**TCP Lot 1 Flex Select**

**TUM-22-1755**

RE: Formal Site Plan Approval; TUM-22-1755  
TCP Lot 1 Flex Select  
29,200 sf building for up to 12 tenants  
8913 Select Court SE, Tumwater, WA 98501

**FORMAL SITE PLAN**

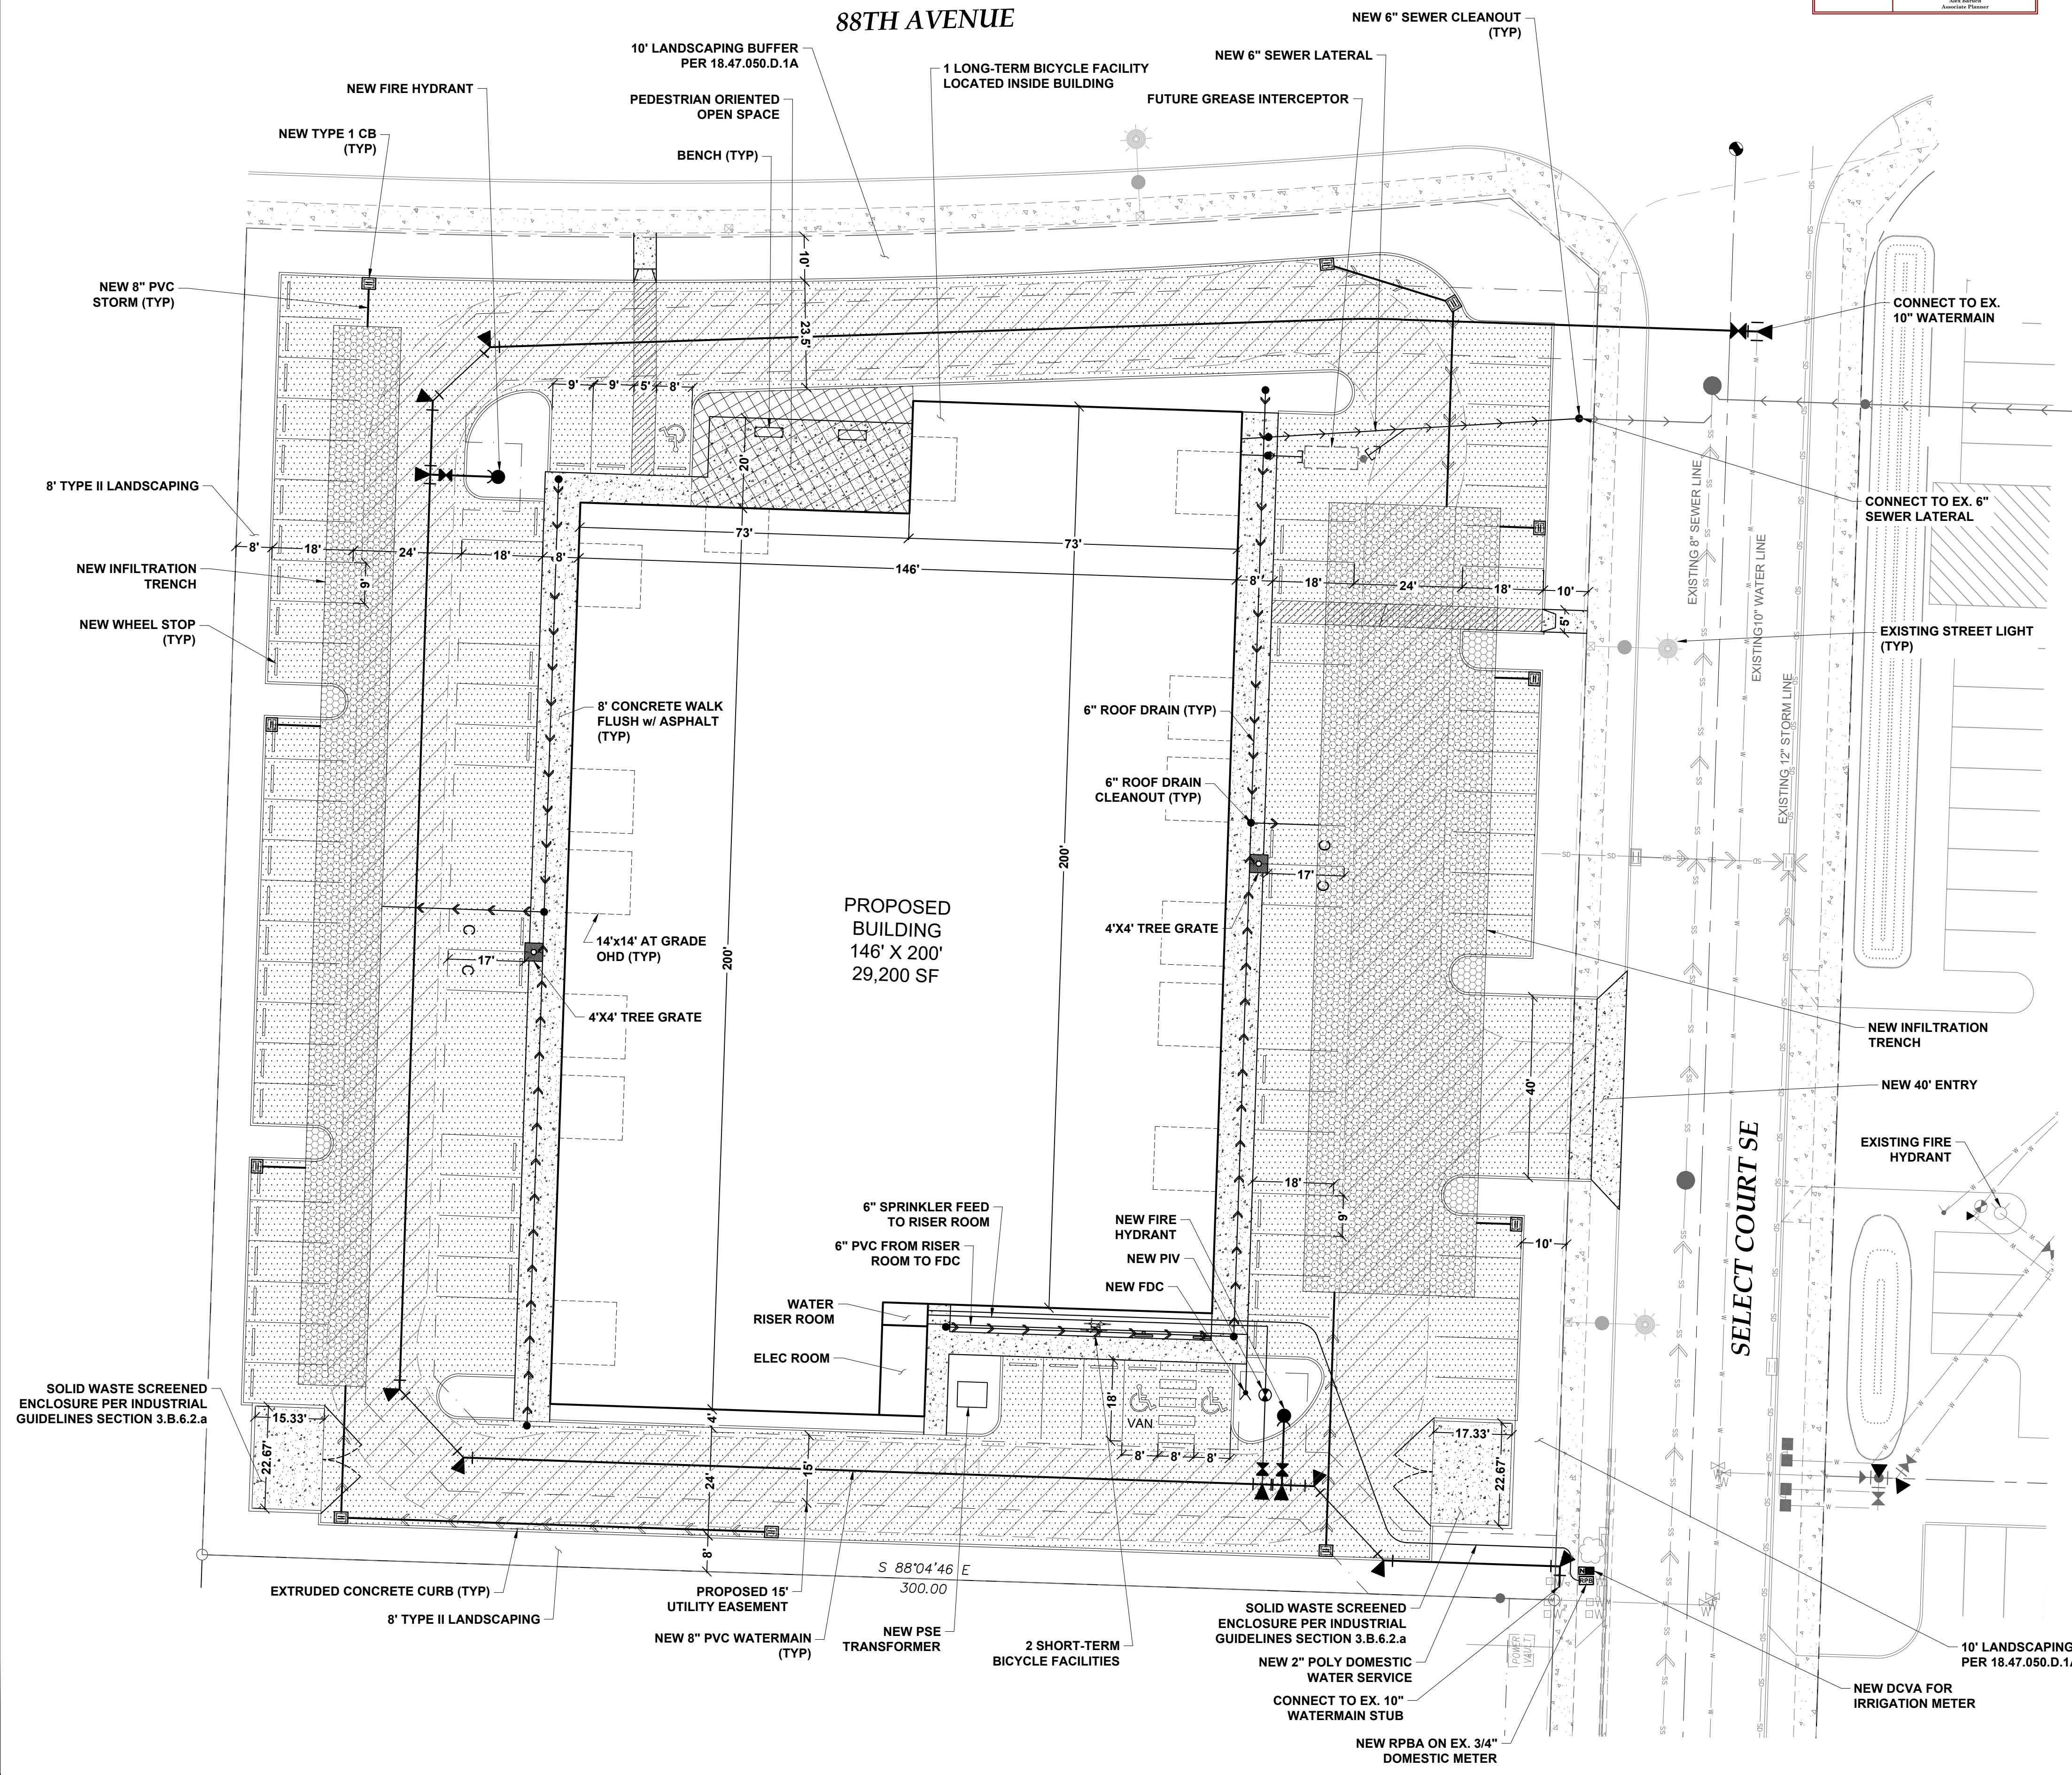
The site plan meets these requirement.

Adequate parking is shown on the site plan. The bike parking is shown as covered and will also need to be lit per the ordinance requirements.

The site plan application materials show appropriate landscape areas. A detailed landscape and irrigation plan are required to be approved prior to site development grading plan approval.

4. The new hydrants/FDC locations submitted on the Formal site plan are **approved** as submitted. Any changes to the approved layout will need to be approved by the Building Official prior to installation.
